Shirley Road / Marshland Road Raised Safety Platform

Scheme design safety audit

Report prepared for
Christchurch City Council

January 2023

Figure 2-1: indicative driveway location

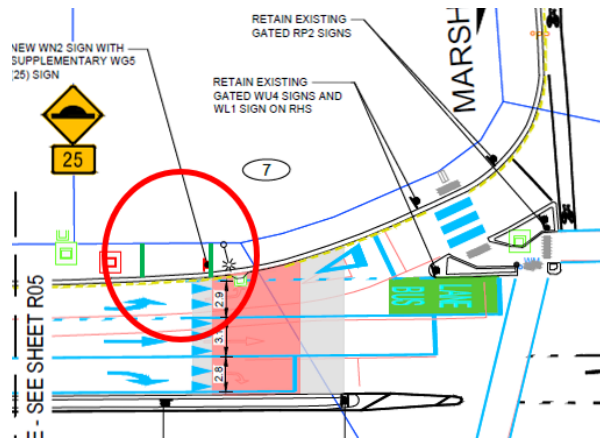
The driveway into 7 Marshland Road (Z – Shirley) is located within the raised safety platform approach ramp. The ramp proximity is not expected to result in loss of control crashes due to the levels required to raise to the platform height

Probability of crash occurring	N/A
Expected crash severity	N/A
Primary treatment recommendations:	
2.1.3.1	Consider relocating the platform away from the driveway
Supporting treatment recommendations:	
2.1.3.2	N/a

Figure 2-2: Extents of bus blocking slip lane

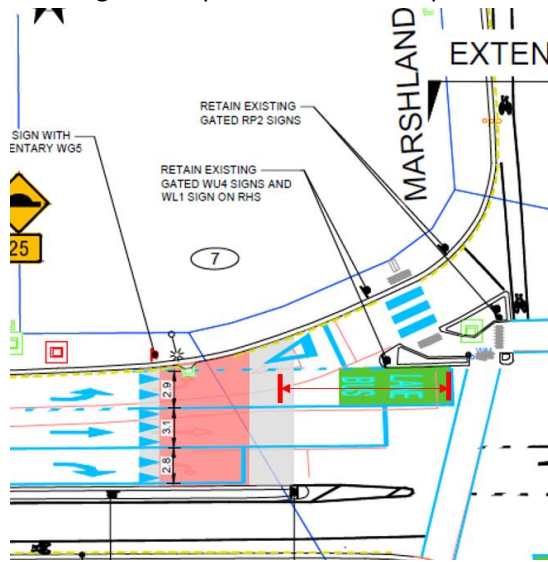
The left turning slip lane from Shirley Road into Marshland Road will be blocked everytime a bus stops in the allocated space at the traffic lights. If the bus stops with the front wheels at the limit line, the front of the bus will encroach the pedestrian crosswalk.

Probability of crash occurring	Unlikely
Expected crash severity	Minor injury
Primary treatment recommendations:	
2.2.1.1	Remove the slip lane

The crash type/s expected rear end crashes between stopped buses and motor vehicles trying to access the turning lane.

- Regular volume of buses (11 per hour)
- High volume of turning vehicles using the slip lane (123 am, 189 noon, and 305 pm peak hour)
- There is roughly a two metre gap between kerb and rear of bus that some drivers may not mistake as being wide enough.
- The downhill platform gradient prior to the bus stop.

2.2.1.2 Re align crosswalk to push the limit line and bus stop back, which would completely block the sliplane.

Figure 2-4: Straight crosswalk option

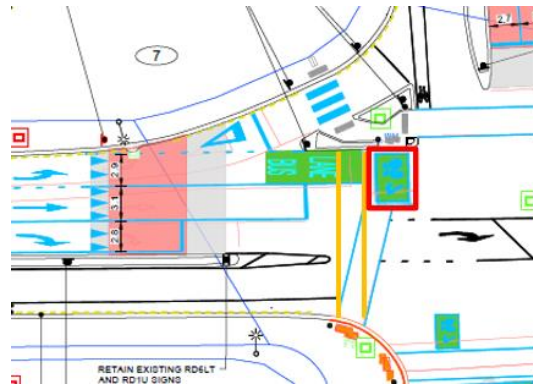
Pedestrians are required to walk on an angle across the western pedestrian crosswalk. This is believed to be a legacy issue from the existing layout.

Due to the legacy layout no hook turn box is possible, users walk further across the road, and some pedestrians go through or around the island and approaching drivers aren't sure if the pedestrians are continuing to the zebra crossing or crossing to the palms.

Probability of crash occurring	N/A
Expected crash severity	N/A
Primary treatment recommendations:	
2.3.1.1	Realign the crosswalk to be straight as shown in Figure 2-4.
Supporting treatment recommendations:	
2.3.1.2	N/a

Figure 2-6: Location of missing continuity lines

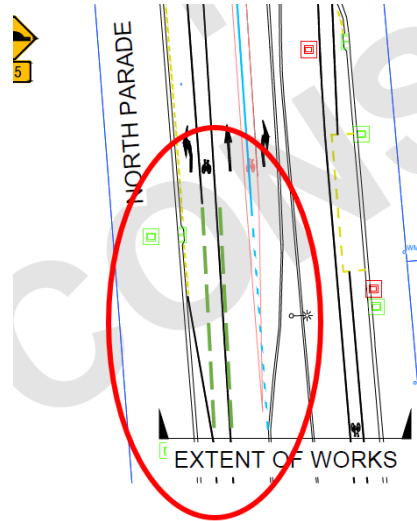
The safety issue is that no continuity lines are shown in the scheme design through the conflict area of vehicles wanting to turn left from the through lane and across the cycle lane, out of North Parade. This can result in drivers crossing in locations that are not anticipated or expected by cyclists.

Probability of crash occurring	Unlikely
Expected crash severity	Minor injury
Primary treatment recommendations:	
2.4.2.1	Provide continuity lines across cycle lanes to indicate where vehicles should travel across the cycle lane.

2.4.2.2	Provide green road marking to highlight the conflict area
---------	---

Figure 2-7: The Palms driveway on New Brighton Road

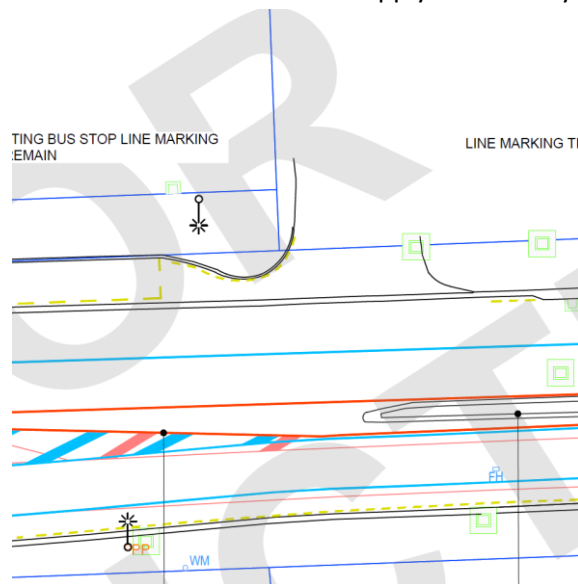
The safety issue is the New Brighton Road entry into The Palms car park will be left-in left-out only. This will cause some drivers to find new routes from what they have previously

done. Drivers can become frustrated with changes that they don't know about or understand the rationale behind the change.

The crash type/s expected is drivers making their previous turns and colliding with through vehicles on New Brighton Road or impacting the mountable median island.

2.4.3.1	Provide no turning signs and arrow road markings from existing palms entry / exit
---------	---

2.4.3.2	Target the consultation information to inform drivers that may have previously used this entry exit to turn right in or out of the Palms driveway on New Brighton Road
---------	--
